WATTS BAR NUCLEAR PLANT

SEISMIC ANALYSIS
CORRECTIVE ACTION PROGRAM PLAN

WATTS BAR NUCLEAR PLANT (WBN) - VERTICAL SLICE REVIEW (VSR) PLAN

Sargent & Lundy Organization Chart
Figure 01.01-1
01.2

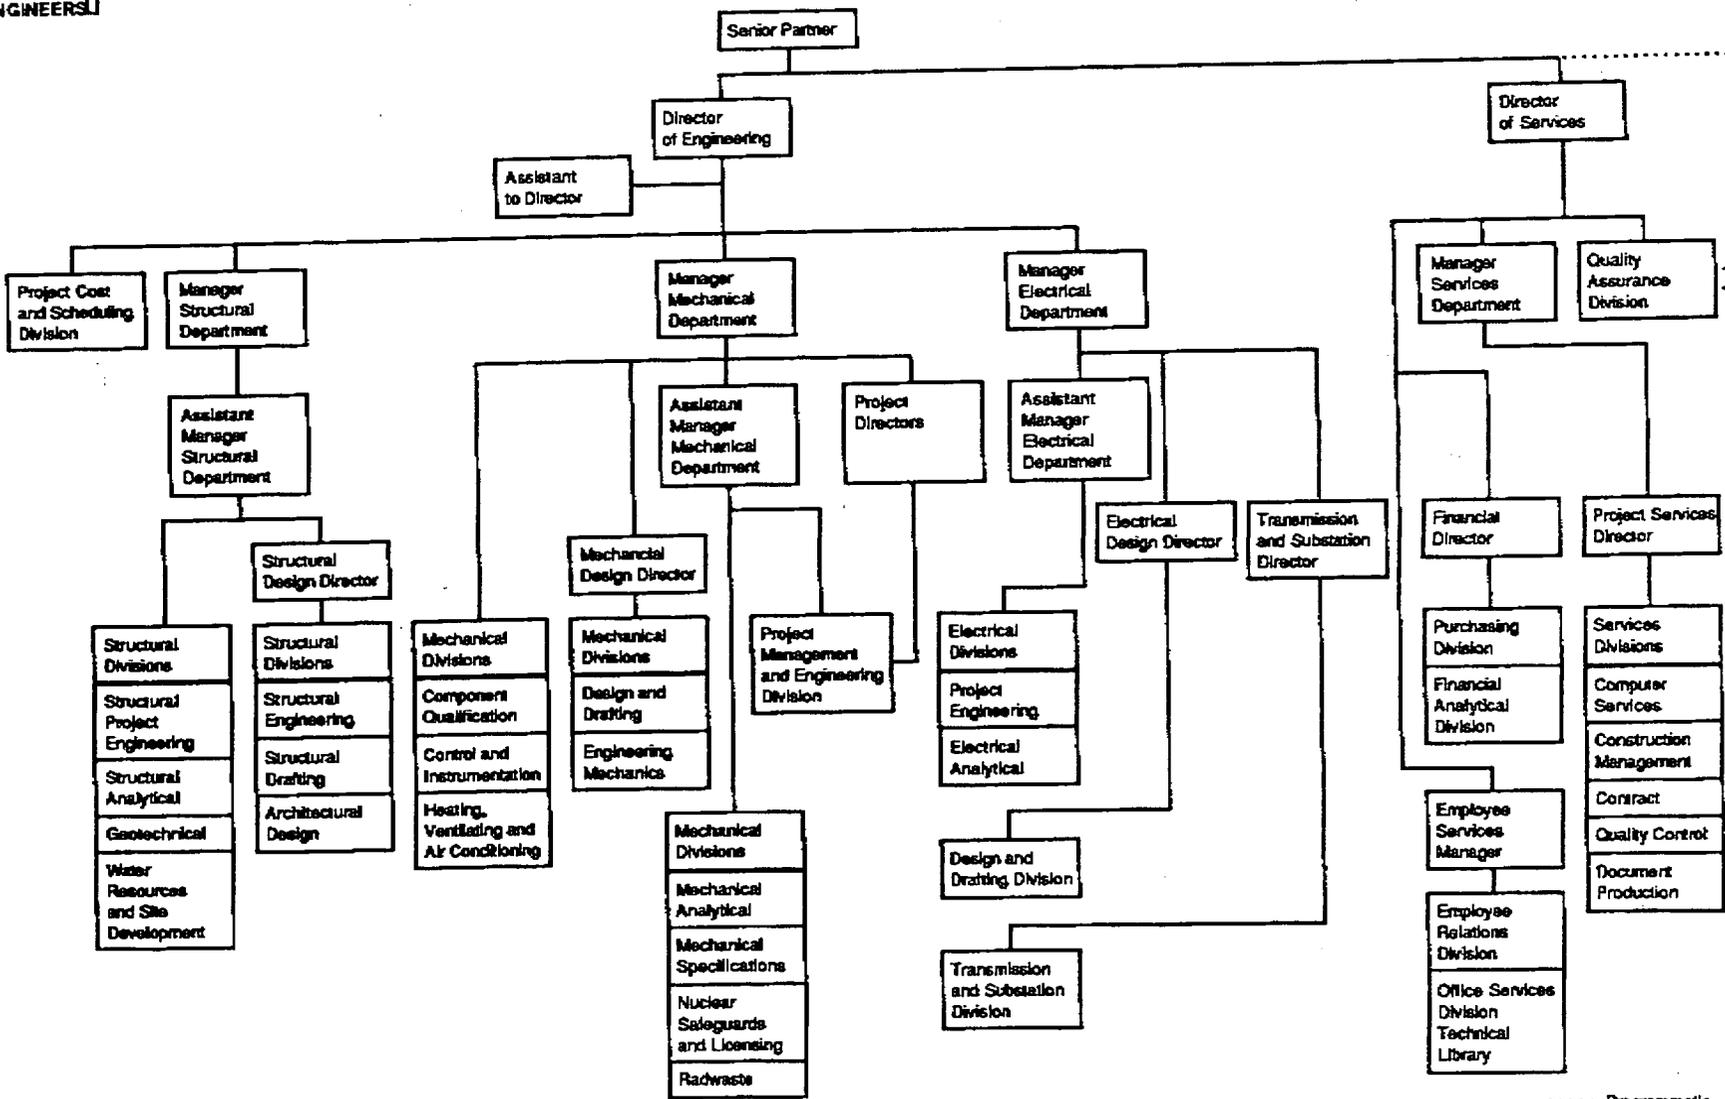
Section V - Who does the Head, Quality Assurance Division report to as described in the Quality Assurance Program for the VSR?

The head of Sargent & Lundy (S&L) Quality Assurance (QA) Division reports to S&L's director of services for QA activities in accordance with the S&L QA manual, as shown on the attached Figure 01.01-1, "Sargent & Lundy Organization Chart," from S&L Topical Report SL-TR-1A, revision 7.

Exhibit IV-1

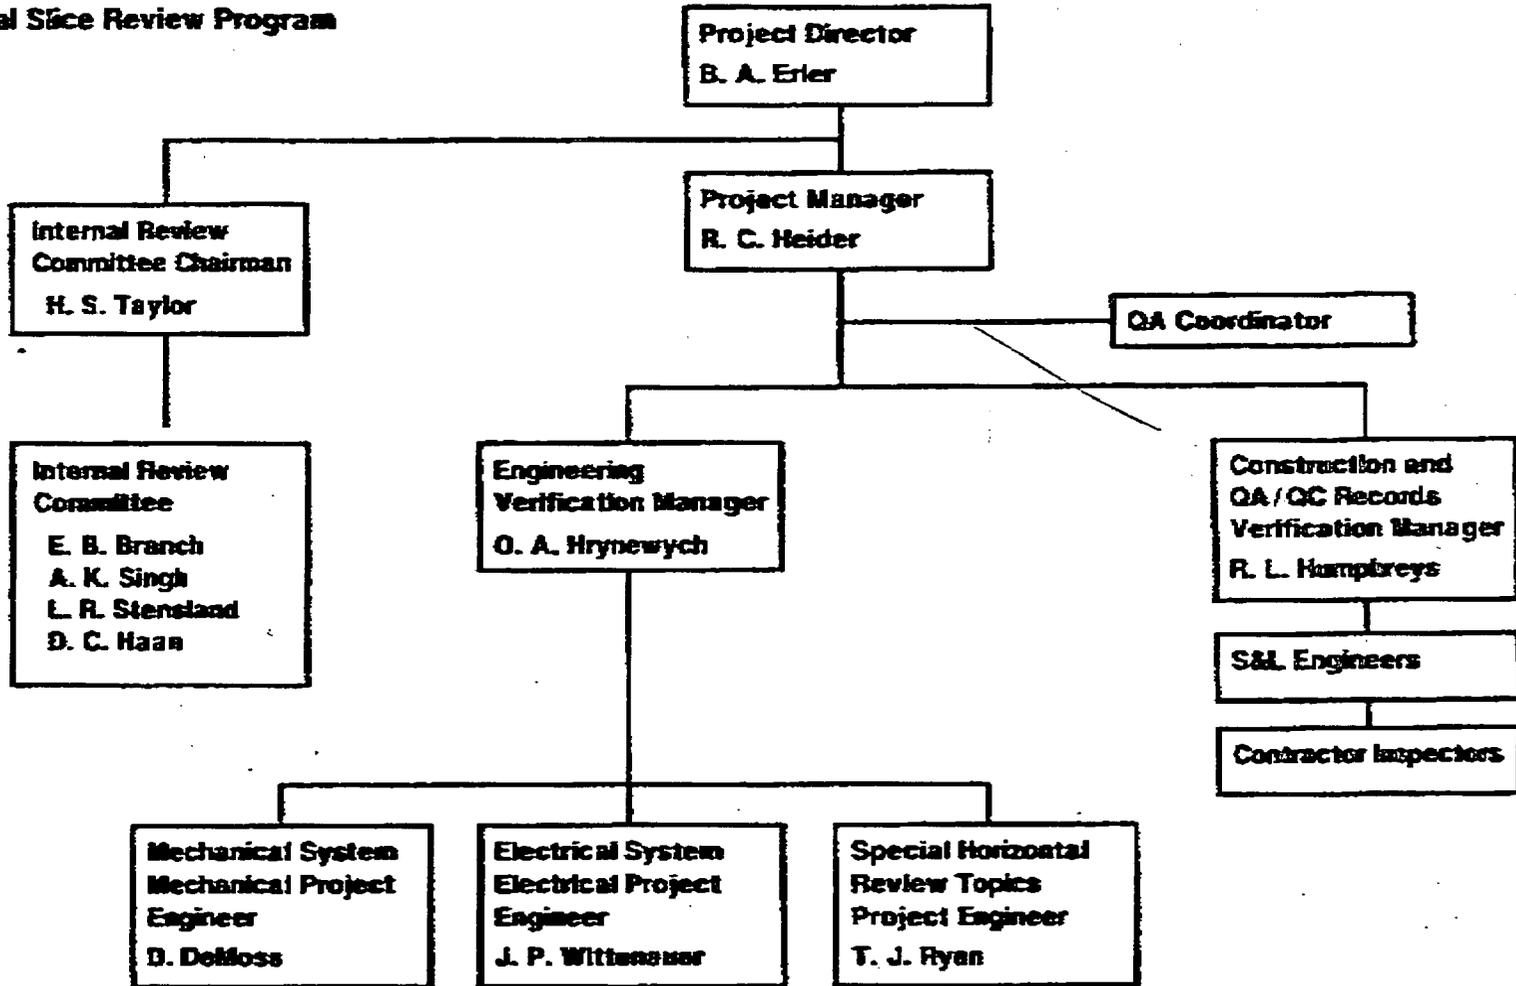
Section V - The Quality Assurance Coordinator reports to the Senior Quality Assurance Coordinator as described in Section 2.2.4. However, the Senior Coordinator does not appear on the organization chart (Exhibit IV-1). Where does the Senior QA Coordinator fit in the organization?

The QA coordinator in the VSRT reports to the project manager for project activities, as shown in the attached Exhibit IV-1. It should be noted that this exhibit, when originally submitted with the VSR plan to NRC, had an error in that it showed the QA coordinator reporting to the project director instead of project manager. Also, D. C. Haan (Internal Review Committee member) and J. P. Wittenauer (Electrical Project Engineer) have replaced R. L. Givan and T. M. McCauley, respectively, due to availability reasons. The exhibit does not show a senior QA coordinator because there is no senior QA coordinator on the project team. The QA coordinator reports to the senior QA coordinator for his non-VSR activities, e.g., administrative and technical direction, and the senior QA coordinator reports to the Head, QA Division, as shown on the attached Figure 01.02-1, "Quality Assurance Division Organization Chart," from S&L Topical Report S1-TR-1A, revision 7.
